Staff Report

Meeting Date: BOZAR, August 26, 2025 RE: 915 Belleview, Hodges

PROJECT TITLE: Hodges (915 Belleview Avenue) residence

<u>SUMMARY:</u> Consideration of the application of **Priscilla Ann Hodges** for site plan modifications to be located at 915 Belleview Avenue, Tract 5, Verzuh Ranch Annexation in the R1D zone.

N SITE 1/8" = 1'-

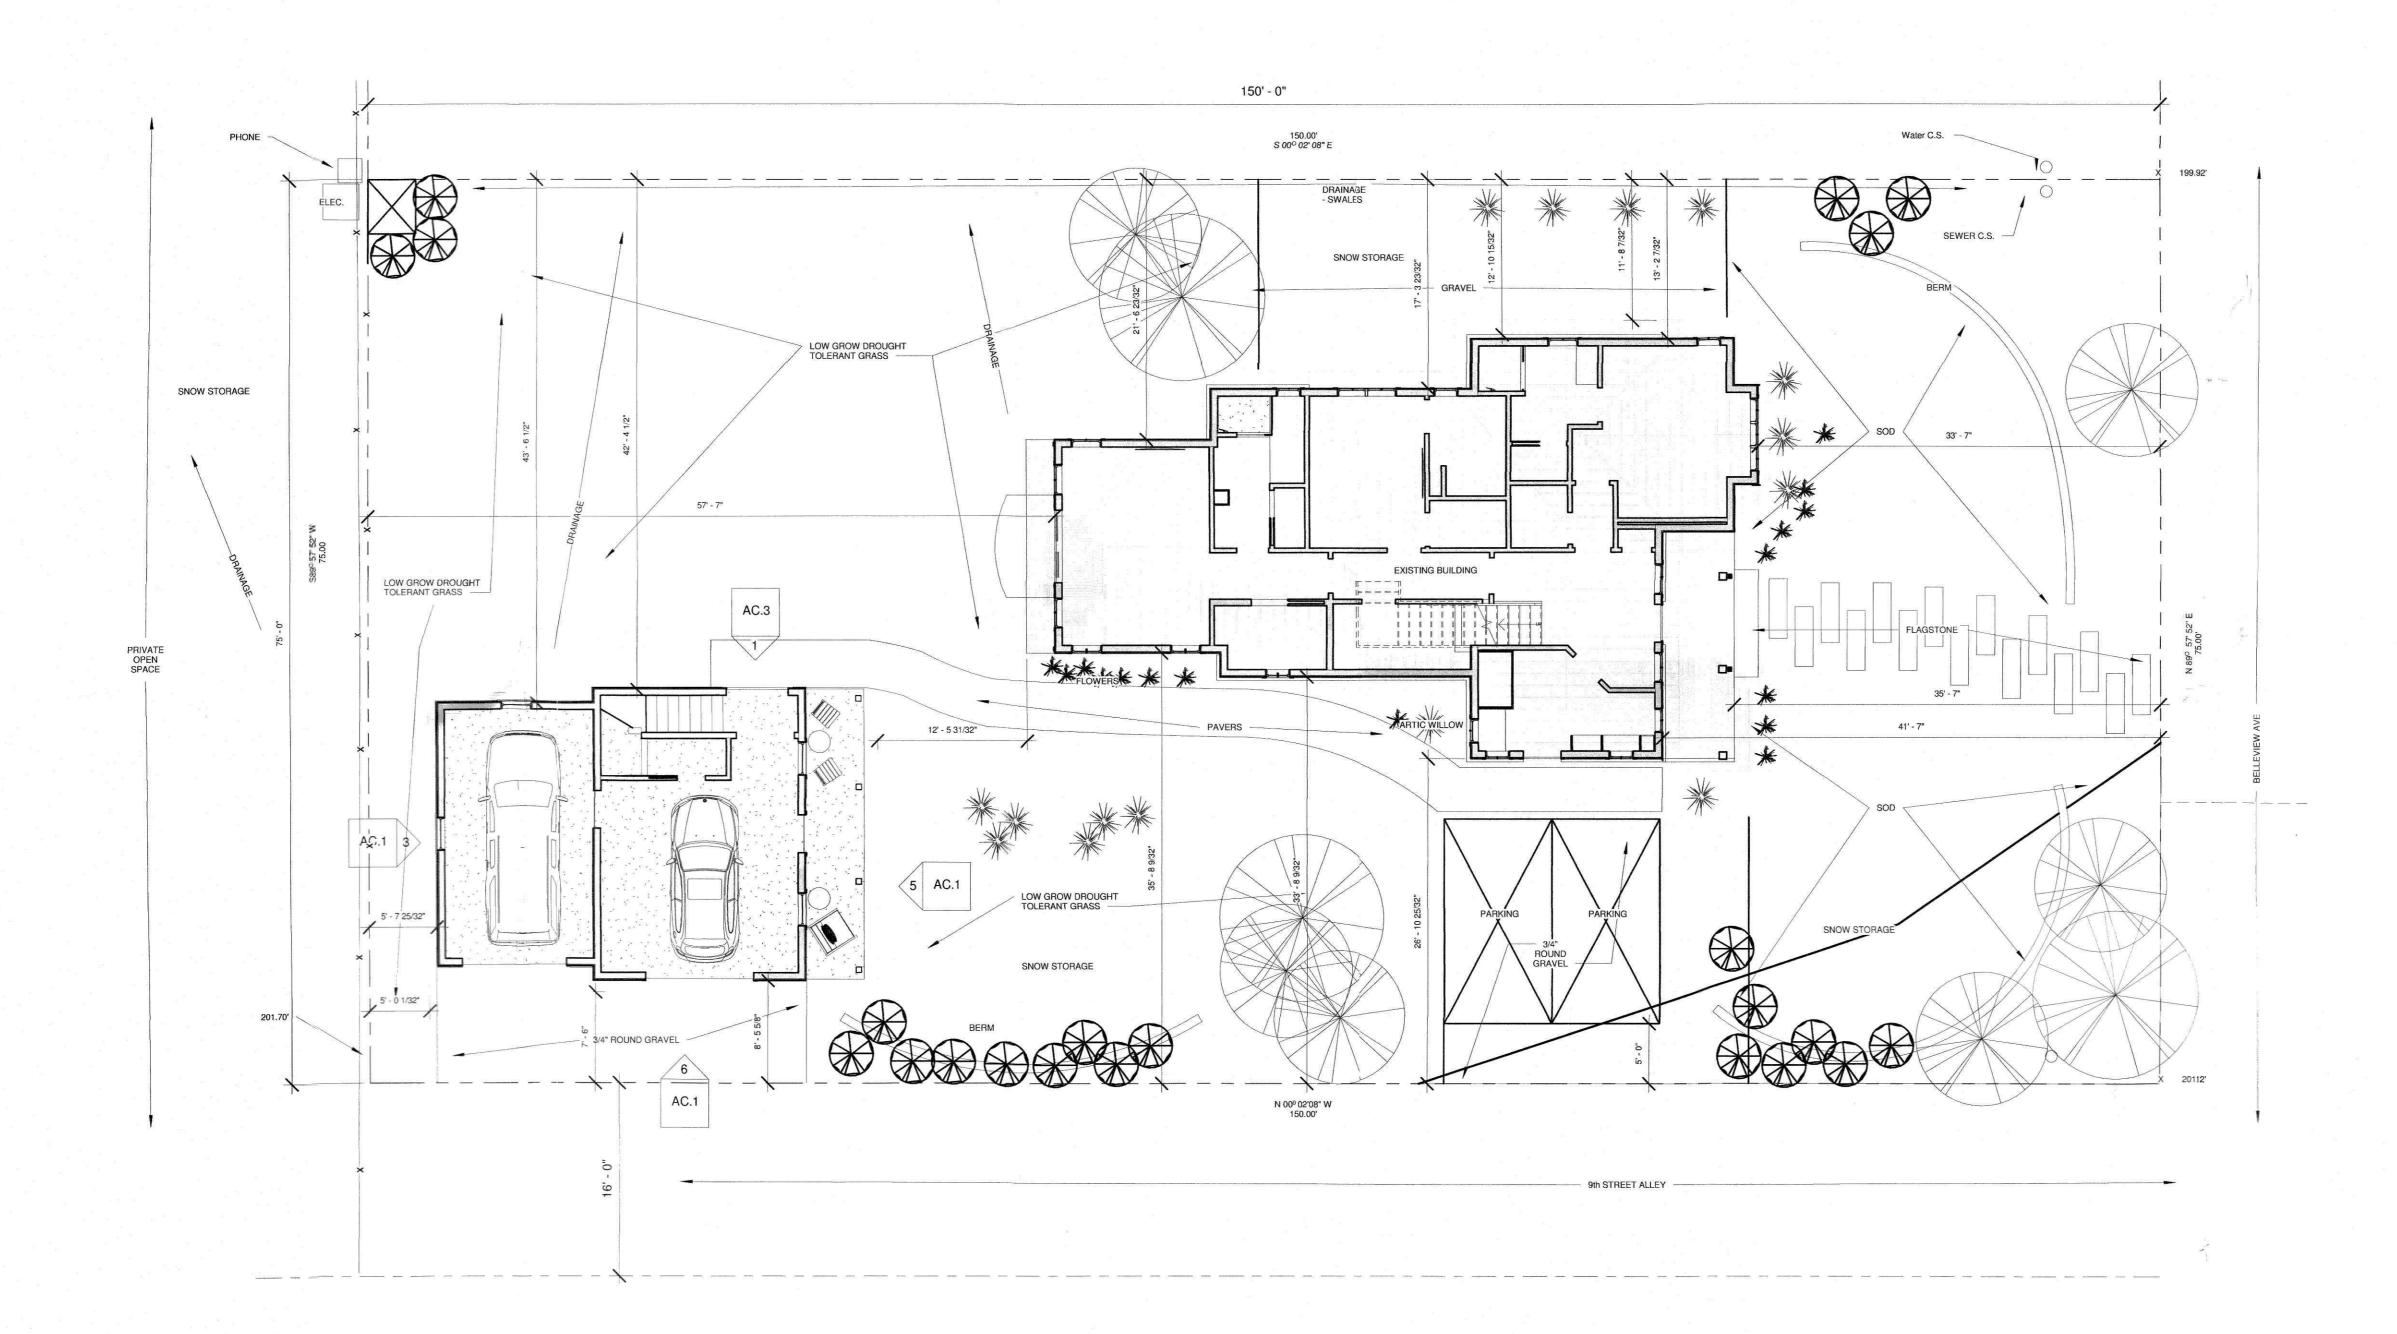
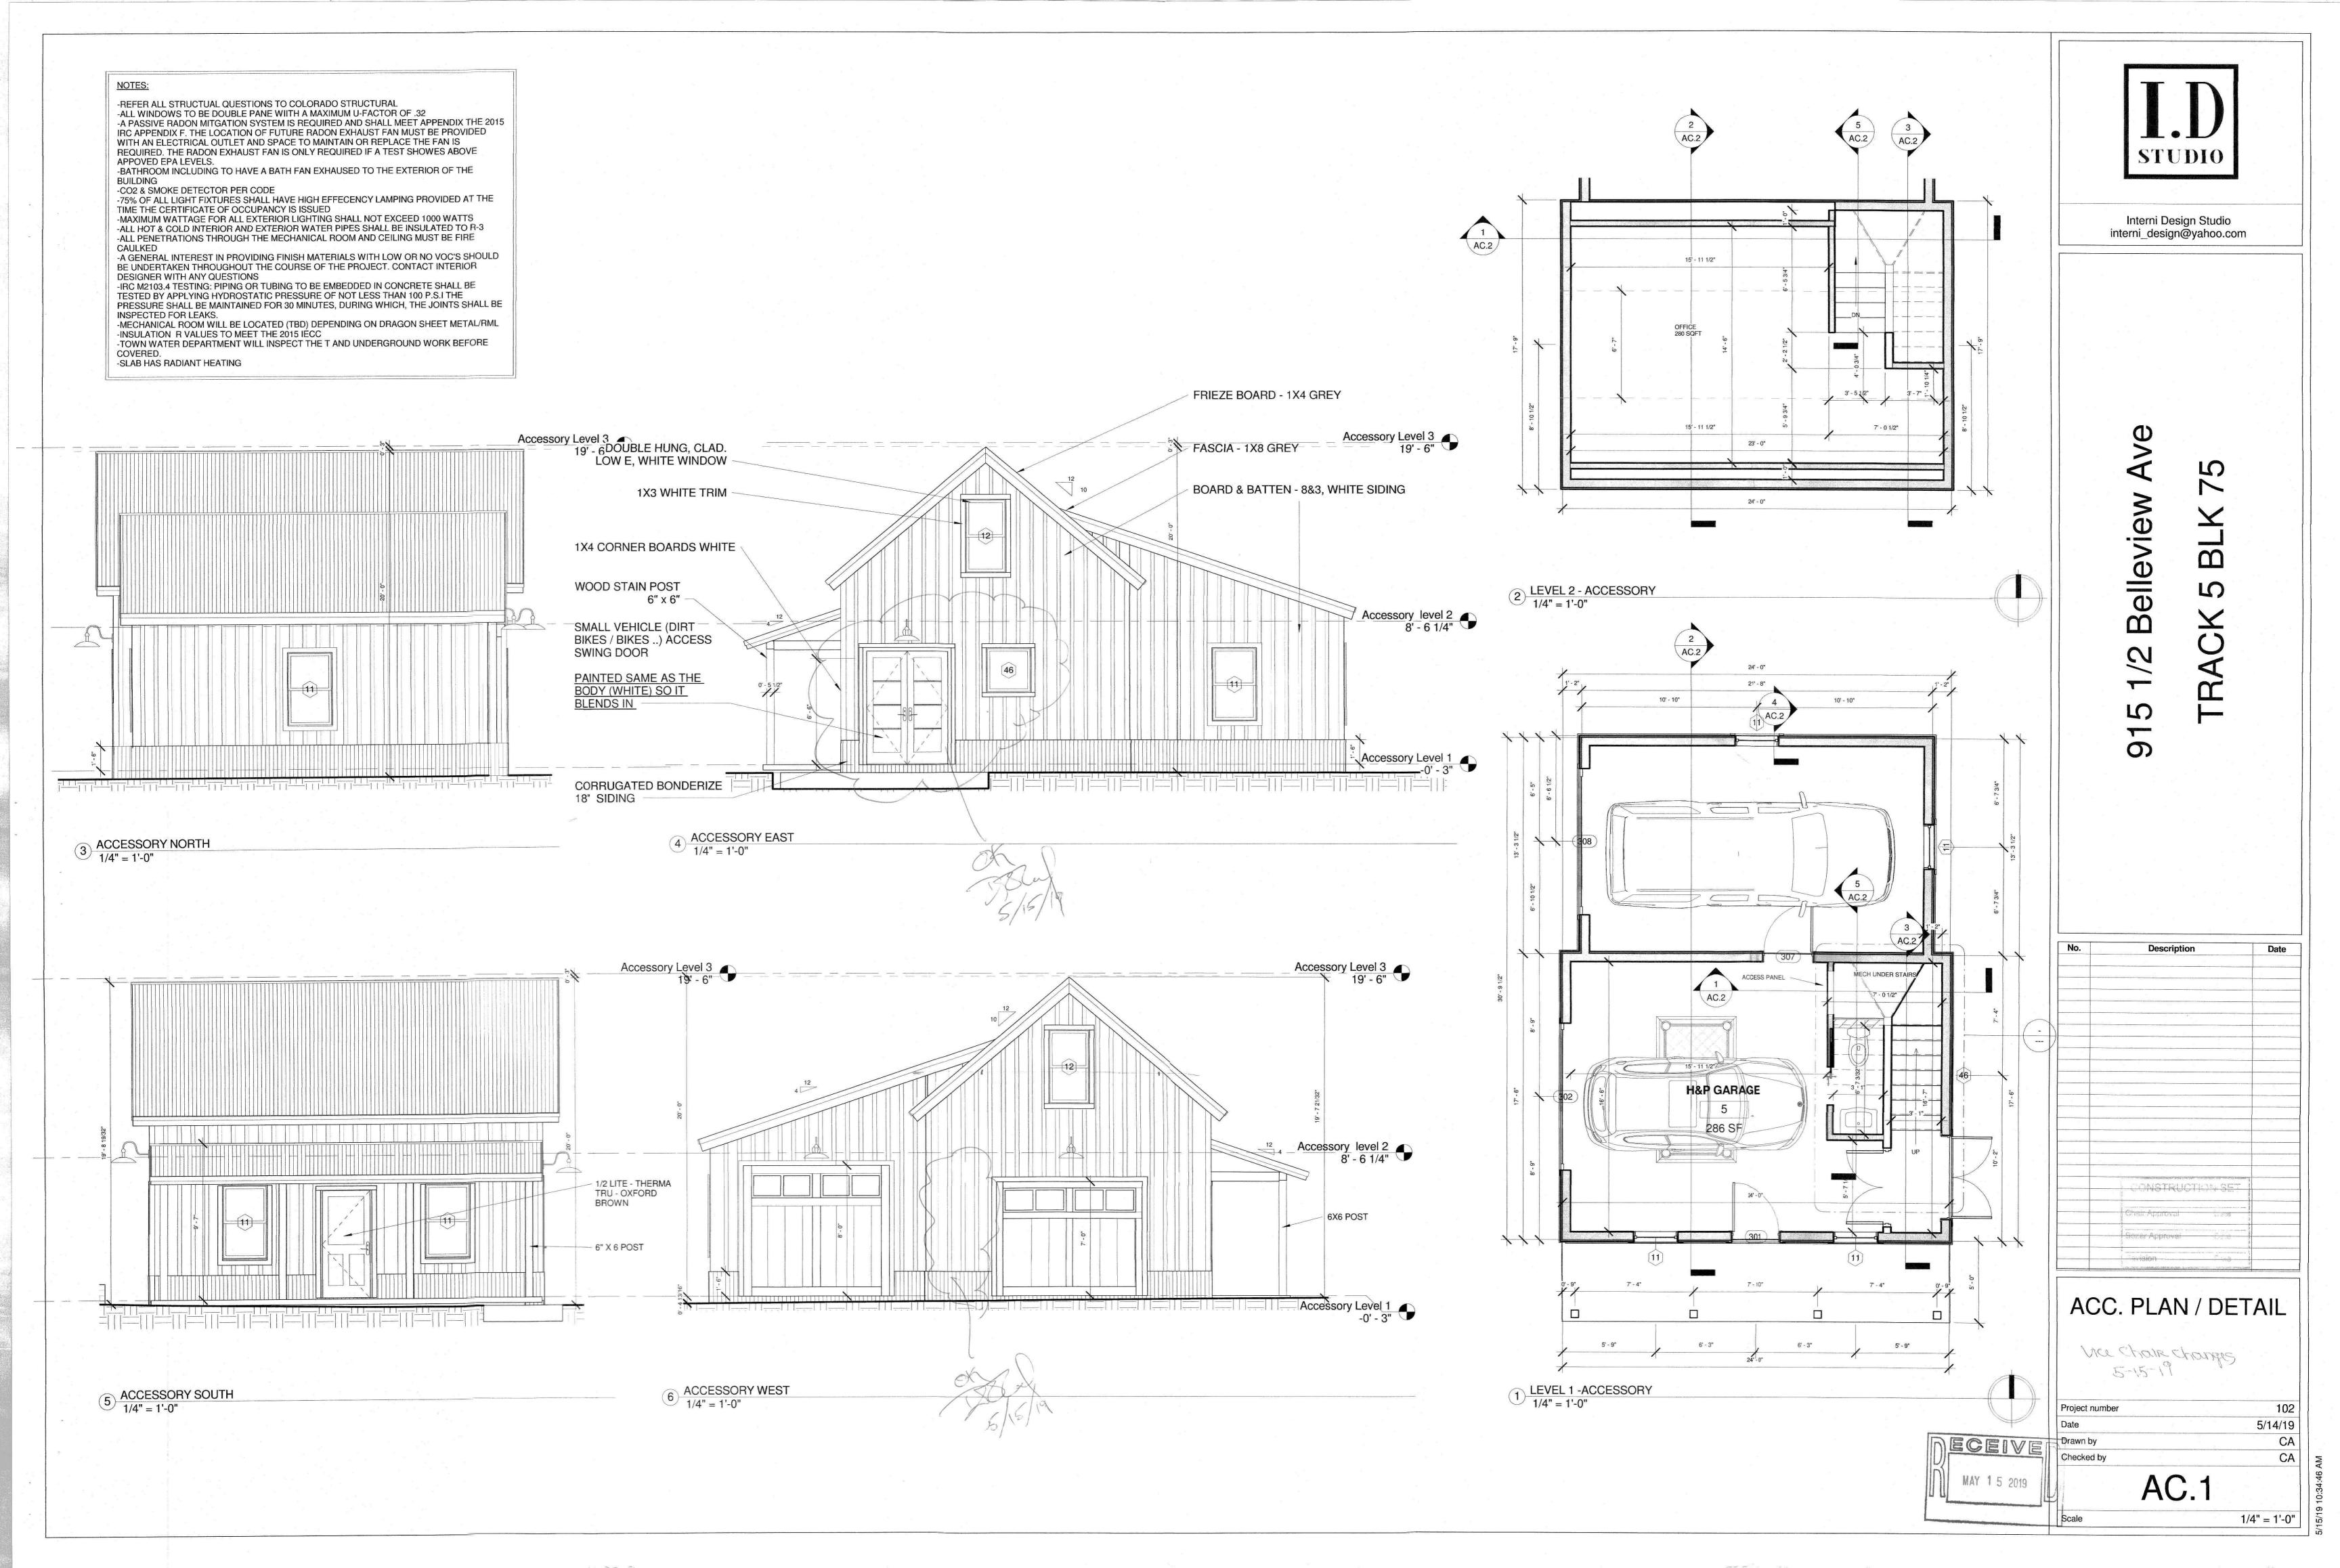
GL	Staff Analysis
4.25 Excessive similarity	No conflict.
4.26 Excessive dissimilarity	Discussion is encouraged regarding the amount of concrete used for the walkways, patio and driveway to determine if it is consistent with other approvals within Town and the R1D zone.

GL	Staff Analysis
2.16 Pervious Materials	GL 2.16 e encourages pervious materials
	over concrete. Discussion is encouraged.
2.28 e &f Parking substrate	Confirmation of the square footage proposed is needed from the applicant for the concrete patio and driveway.
	The applicant has described the need for the concrete relating to a health condition and need to maintain accessibility of the site. The concrete material appears to conflict with GL 2.28e&f. Discussion is encouraged to determine if the amount proposed can be supported.
